# Town of Winchester

June 29, 2020

RE: Winchester Center Station – MBTA Cost Sharing Proposal

*Quill Rotary Underpass*

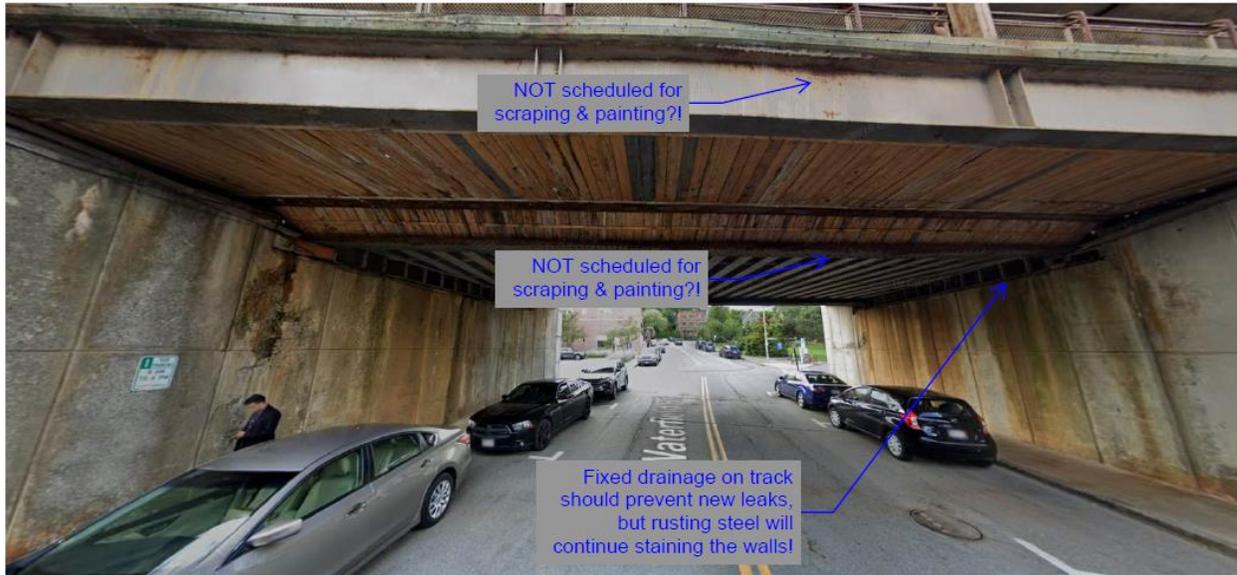
## (1) Painting of Pedestrian Tunnel

The MBTA has indicated that painting the existing pedestrian tunnel between the Aberjona and Waterfield Lots is not currently included in the scope of work for the project; and that if the Town is interested in pursuing this work, it could do so at a cost of \$17,500.

The Town would be interested in cost sharing for this item; however, we do ask that the MBTA reconsider this, as we feel that cleaning and repainting of the pedestrian tunnel should be considered part of the MBTA's normal operations and maintenance for the station, which is now 50-years old. Further, the Town strongly encourages the MBTA to add cleaning of the concrete at the Waterfield Road and Quill Rotary underpasses, and repainting of the rusting steel the two street crossings to the project scope of work. Photos of the two areas are provided below, which show stained concrete and rusted structures resulting from years of deterioration from poor drainage on the platforms above. The Town feels strongly that restoration of these areas should be included in the MBTA's base contract, and not as part of a cost sharing agreement with the Town.
